# Chantik Garments Ltd.

# Observations

# High loading on roof slab

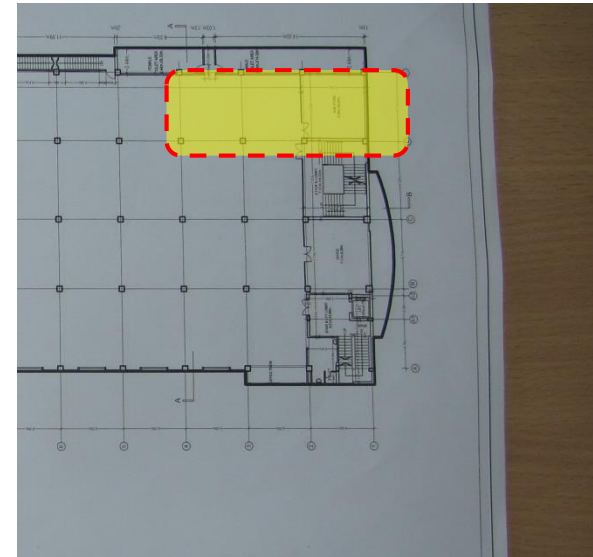
1.3 m high brick pile on roof slab of the processing building results in high loads on roof slab.

Building Engineer to make sure allowable loads are not exceeded during the construction stage. Loading to be controlled on roof with loading not to exceed  $2\text{Kn/m}^2$
